## **ADDENDUM NO. 3**

**RE:** HOPKINSVILLE WATER ENVIRONMENT AUTHORITY  
SOUTH HOPKINSVILLE PUMP STATION UPGRADES  
CONTRACT # 111-2008-03

**FROM:** JV ENGINEERING, INC.  
Jeff Vaughan, P.E.  
5100 Linbar Drive, Suite 106  
Nashville, Tennessee 37211  
(615) 781-8725  
(615) 781-8727 (fax)

**Exhibit "A"**  
 Connection Detail  
 C-111 Oak Grove Interconnect  
 Division B, Line A  
 Station 4+20

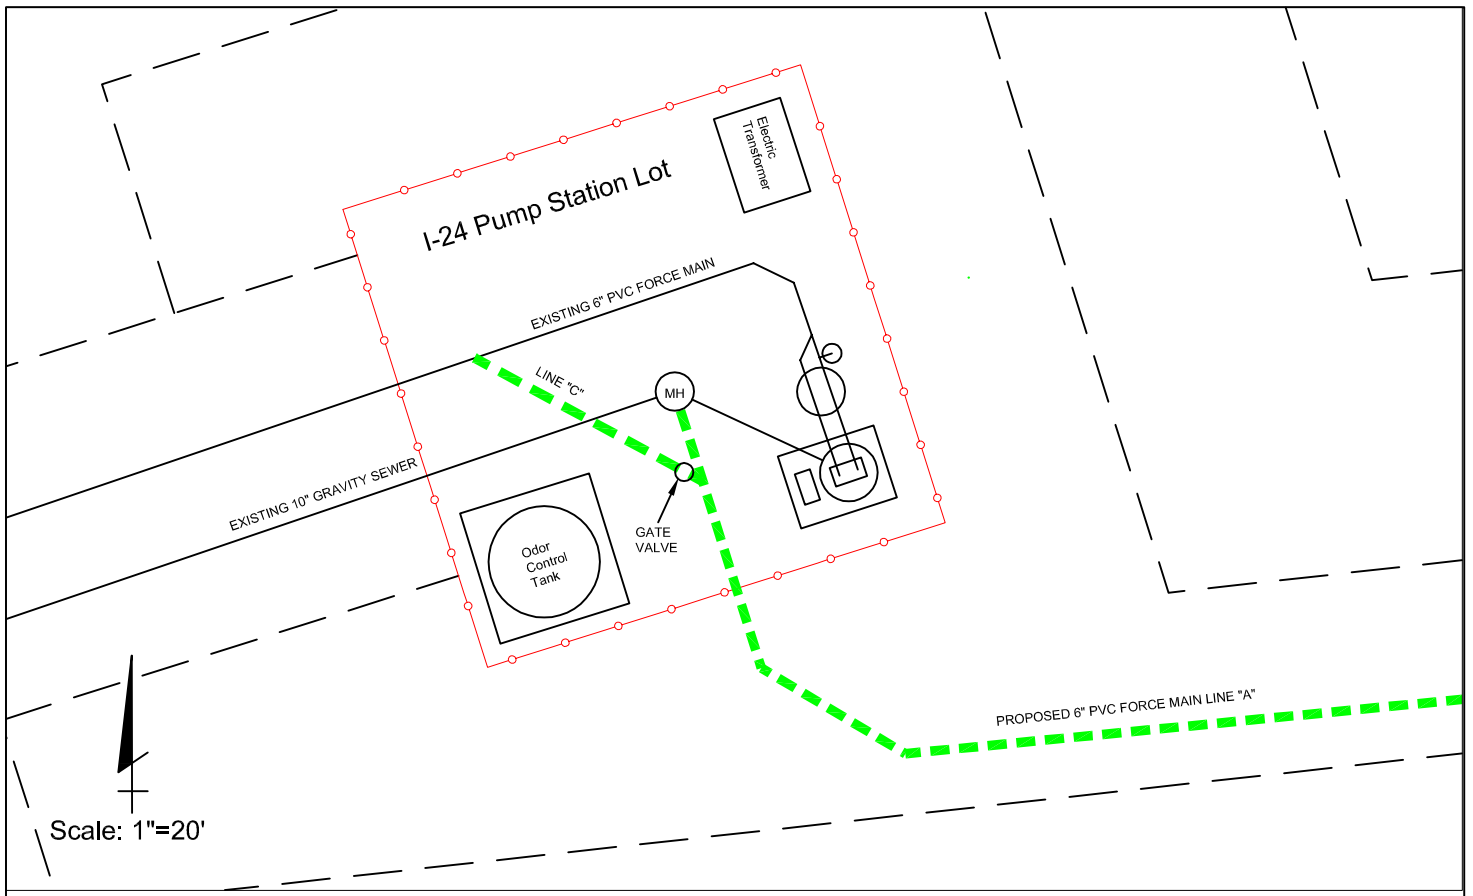
- ▶ For the installation of the force main piping to connect the new 6" Naomi Lane force main into the existing 6" force main, as detailed in the attached Exhibit "A", the contractor's bid shall include concrete blocking **and restrained joints** on all fittings. All other force main fittings shall require concrete blocking only.

1. The plans reference a Line "B" however, this detail eliminates Line "B".
2. Install restrained joints & concrete thrust blocking on all fittings shown here.

As-Built information is unavailable for the location, size, type and fitting arrangement on this existing force main. The actual tie-in and fittings required may vary from that shown in this detail.

**Exhibit "B"**  
Connection Detail  
C-111 Oak Grove Interconnect  
Division B, Line A  
Station 53+58

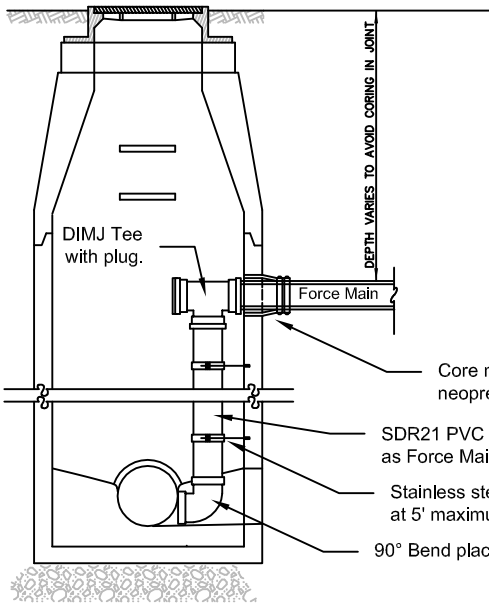
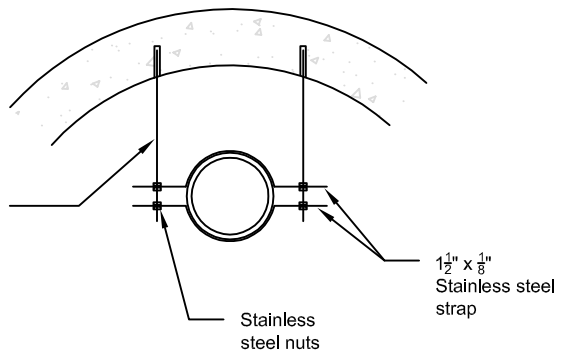
- ▶ Details of the new 6" force main connection to the Naomi Lane force main and the existing piping at the I-24 Sewage PS have been developed and are included as Attachments "A" and "B" to this Addendum.

1. Neoprene boot must meet ASTM C443 and have stainless steel internal expanding band. The boot shall have two grooves for installing two stainless steel contracting clamps.
2. Unless otherwise noted, all stainless steel shall be 316.
